# HIGH SPEED RAIL (LONDON - WEST MIDLANDS)

## Supplementary Environmental Statement and Additional Provision 2 Environmental Statement

CFA26 | Washwood Heath to Curzon Street

July 2015

Figure 1: Location of changes to the design or construction assumptions not requiring a change to the Bill in CFA26

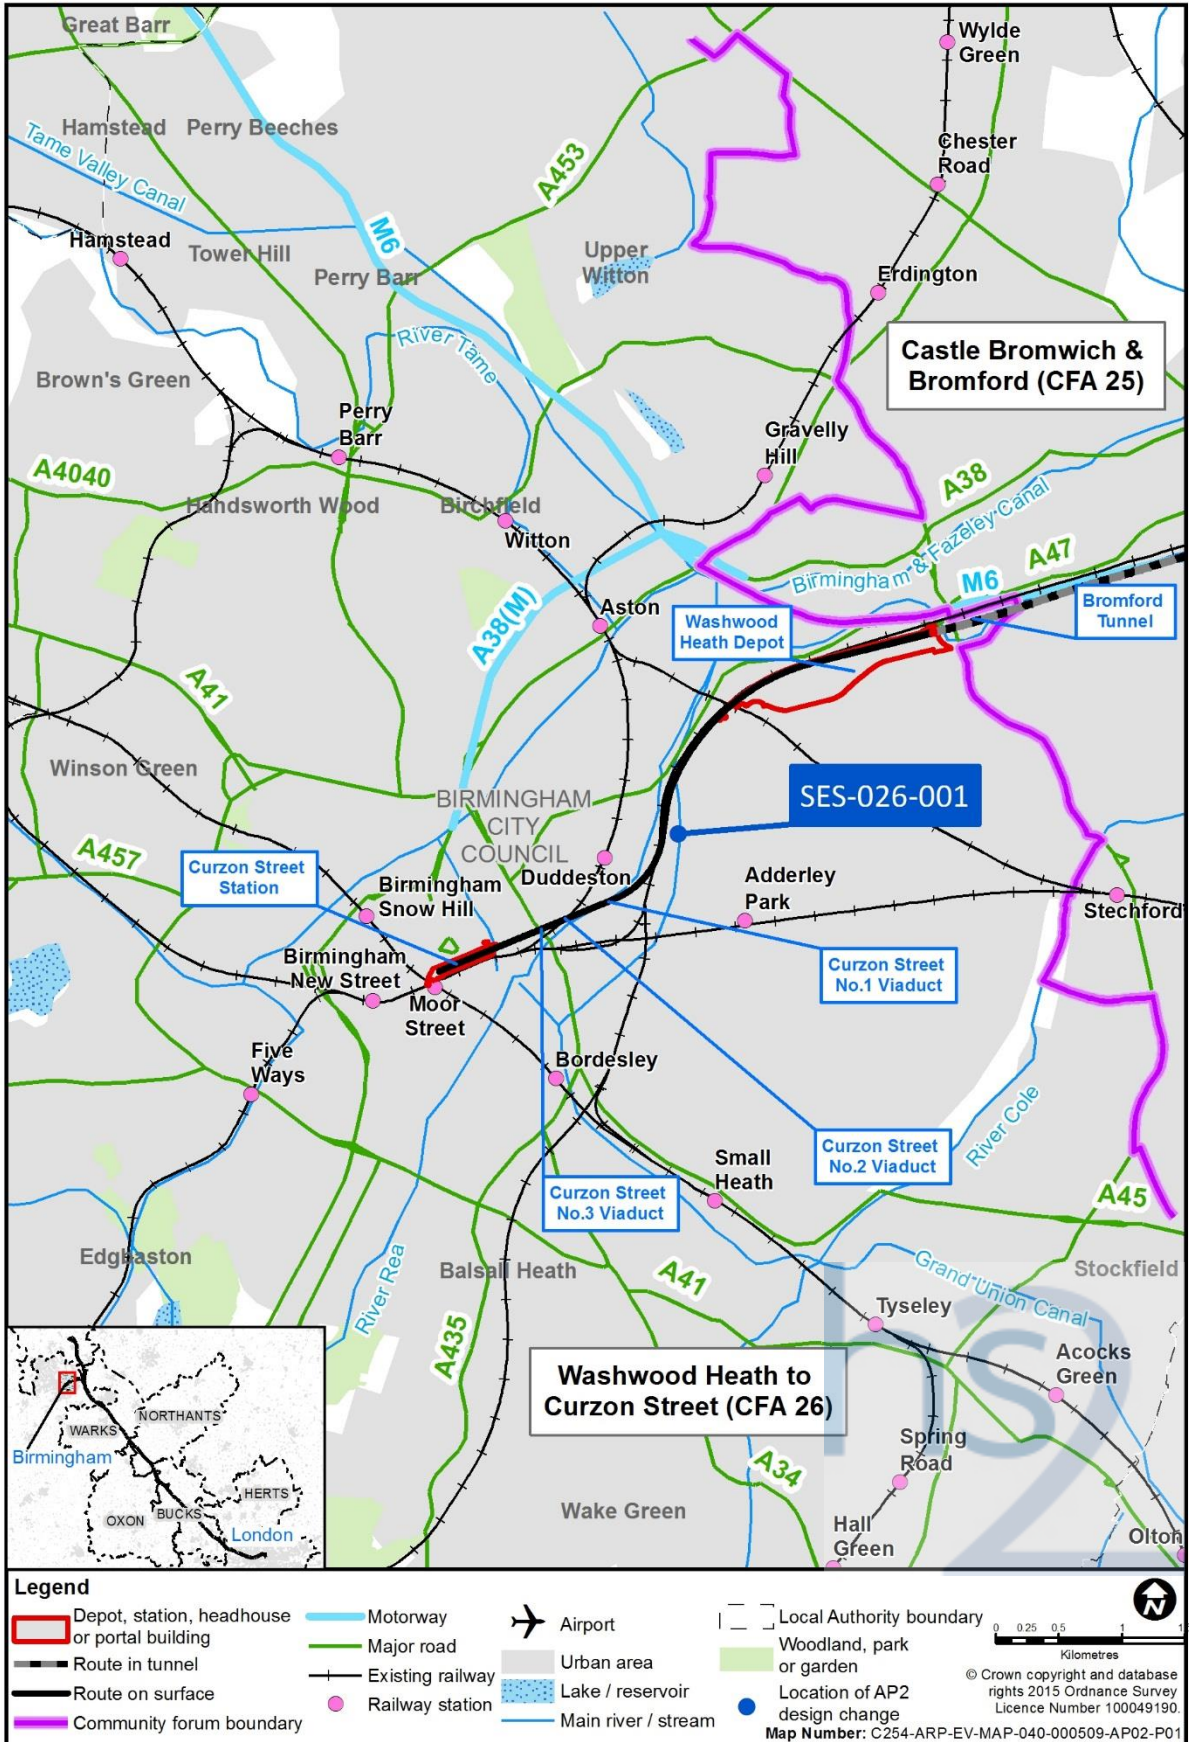
- 2.2.1 Table 1 provides a summary of the changes to the design or construction assumptions not requiring a change to the Bill which will result in new or different significant effects in the Washwood Heath to Curzon Street community forum area (CFA26). Figure 1 shows the locations.

- 2.2.3 Since submission of the Bill it has been identified that the road network within Network Park Industrial Estate is privately owned and therefore rights of access are needed. Rights of access are to be included within the limits of the Bill and are detailed within AP2 change, AP2-026-003, reported in Part 2 of this CFA report.

Figure 2: Locations of amendments in CFA26

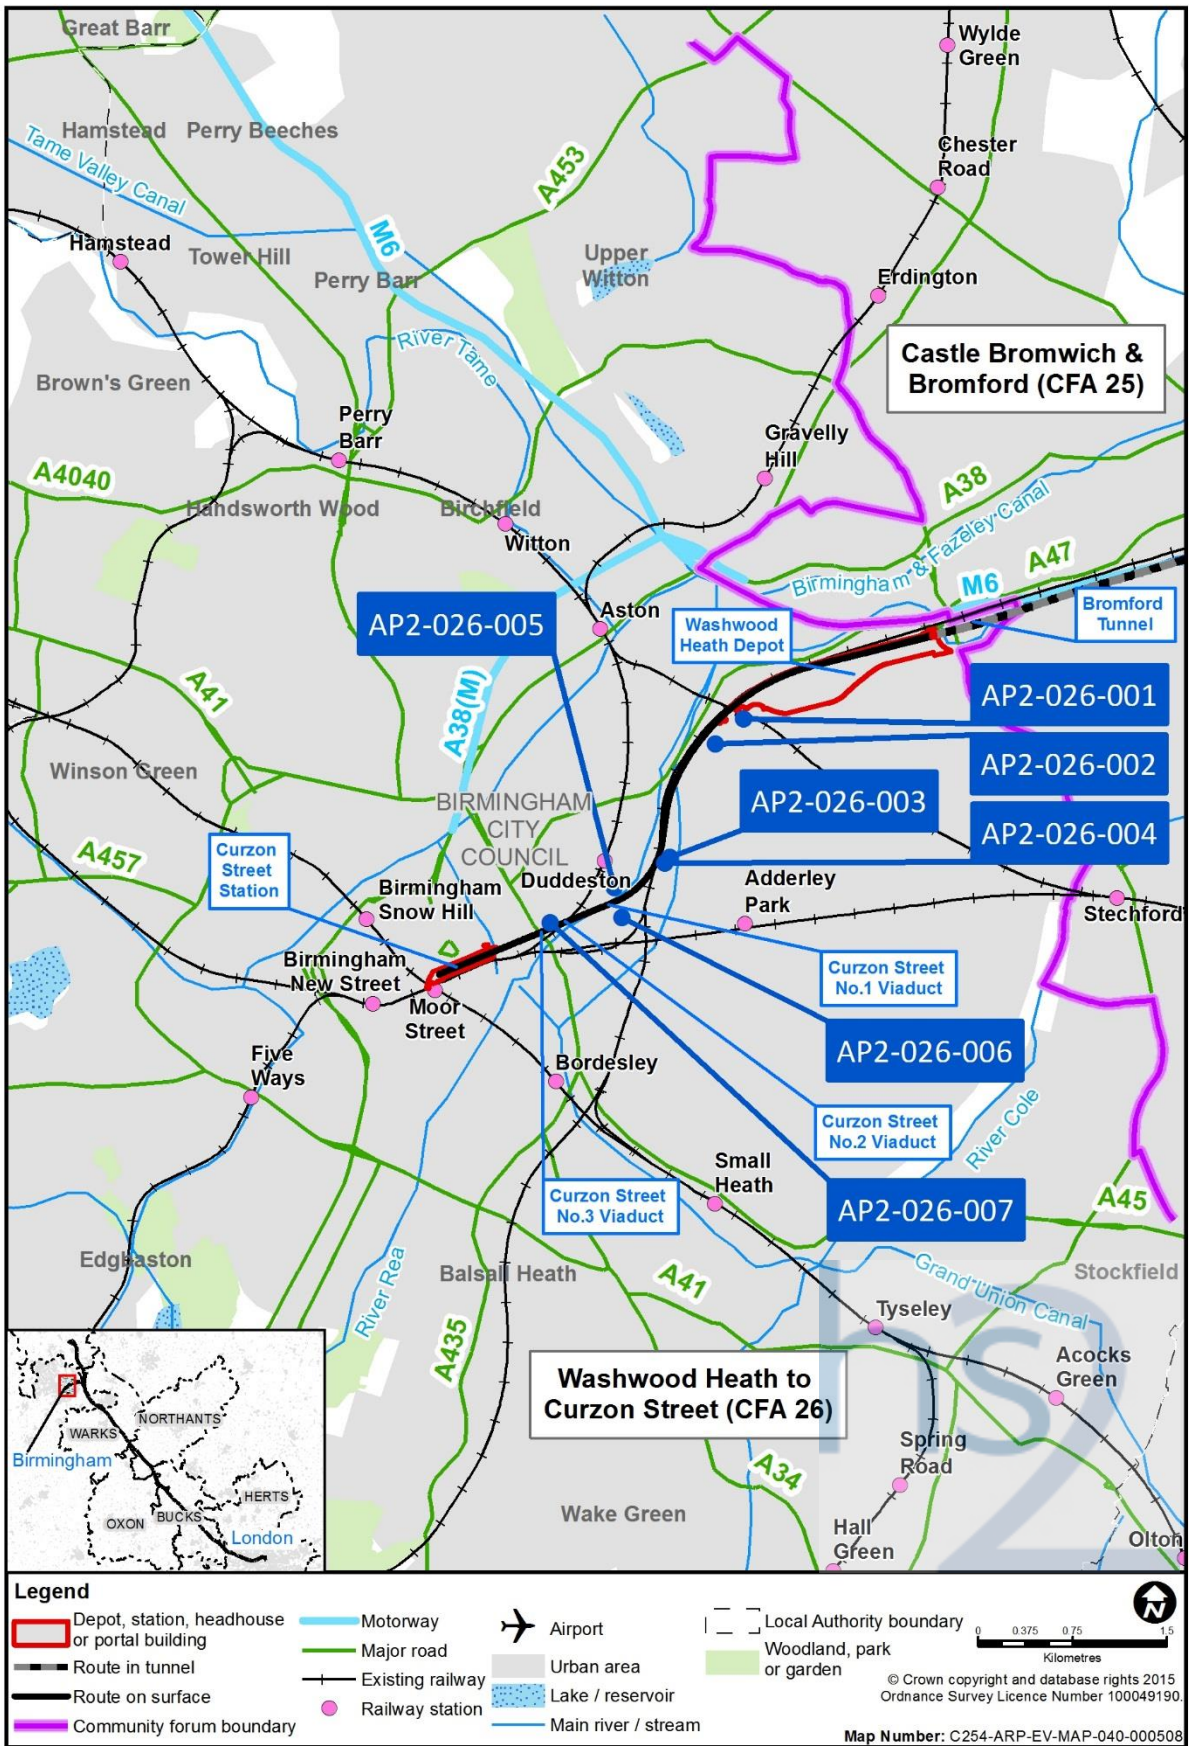
Figure 2 shows the locations.

Name of amendment	Description of the original scheme or AP1 revised scheme	Description of the AP2 revised scheme
Improvement of Aston Church Road/Arley Road junction (AP2-026-001)	Aston Church Road/Arley Road junction would be permanently realigned by approximately 3m to the north as part of construction of the Aston Church Road overbridge.  Aston Church Road and Arley Road would be used as construction traffic routes for works to be undertaken within Saltley Business Park, including demolition of commercial buildings, diversion of utilities and construction of the Aston Church Road overbridge.	Aston Church Road/Arley Road junction will be realigned 7m further north to allow for safe simultaneous HGV movements within lanes through the junction. All works will be within the existing limits of the Bill. However, the land will be required permanently rather than temporarily as specified in the Bill.

Additional access rights for maintenance and operational access on Cumbria Way (AP2-026-002)	Use of a section of Cumbria Way as a construction traffic route for demolition of commercial properties within Saltley Business Park and to provide operational access to the carriage wash.	Permanent access rights are required along the entire length of Cumbria Way, a privately owned road, for maintenance and operational access to the carriage wash.
Additional access rights for construction traffic routes within Network Park Industrial Estate (AP2-026-003)	Temporary use of the road network within Network Park Industrial Estate as a construction traffic route to undertake utility works and the construction of an embankment and a replacement bridge over Duddeston Mill Road.	The original scheme has not changed, however the road network within Network Park Industrial Estate is privately owned and temporary access rights are required.

Additional land required for car parking at Network Park Industrial Estate (AP2-026-004)	Land required permanently for construction of the HS2 route, which would pass through Network Park Industrial Estate, and the diversion of utilities resulting in a permanent and temporary loss of car parking spaces and the loss of a loading bay.	Provision of temporary and permanent car parking spaces to replace the losses under the original scheme. A small area of additional land is required for the provision of temporary car parking spaces and is outside of the original limits of the Bill.
Additional access rights for access to replacement car parking at Birmingham Museum Collections	Land required within Birmingham Museum Collections Centre for the construction of Curzon Street No. 1 viaduct, part of which	Provision of an alternative temporary access to Birmingham Museum Collections Centre rear delivery yard and loading bays

Name of amendment	Description of the original scheme or AP1 revised scheme	Description of the AP2 revised scheme
Centre (AP2-026-005)	would be within the Birmingham Museum Collections Centre, and provision of a construction haul route and diversion of a sewer. Works would restrict the use of the Birmingham Museum Collections Centre rear delivery yard and result in the temporary loss of three loading bays and informal car parking for visitors.	from a private access off Dolman Street to the north-east of Birmingham Museum Collections Centre. Land is required temporarily for the access.  Temporary replacement of informal car parking to the north of the Birmingham Museum Collections Centre rear delivery yard within the limits identified in the Bill.
Additional land for the reconfiguration of Freightliner Terminal Depot and the provision of rail sidings (AP2-026-006)	Curzon Street No.1 viaduct would pass through part of the Freightliner Terminal Depot resulting in the demolition of buildings and loss of 40 unmarked HGV spaces.	The remaining area of Freightliner Terminal Depot will be temporarily acquired to reconfigure the depot site (relocation of a trailer park and storage area and reconfiguring internal roads, buildings and utilities) and provision of rail sidings off the Birmingham to Derby line.  A new construction compound, Freightliner satellite construction compound, will be required to support the works which will be located within the depot site. Access to the compound will be via Landor Street.  An additional site haul route for Curzon Street No. 1 viaduct will be provided to the south of the River Rea off Erskine Street.

Additional land required for replacement car parking at West Midlands Fire Service headquarters (AP2-026-007)	Land required permanently for the construction of Curzon Street No.2 viaduct and Curzon Street No.3 viaduct would result in the loss of access to the service yard and four loading bays and the adjacent off-site two storey car park at the West Midlands Fire Service headquarters.  Construction works would also require the removal of the existing ambulance dispatch point, access to the viaduct arches and other existing infrastructure such as the water tanks.	A permanent replacement three storey car park will be provided on the site of the existing off-site two storey car park. An additional area of land will be required temporarily for demolition and construction working area and access.  During construction, works will be phased and there will be a number of car parking solutions implemented to reflect the phased works, within the limits defined in the Bill. The phased car parking solutions will be implemented to mitigate the temporary loss of car parking.
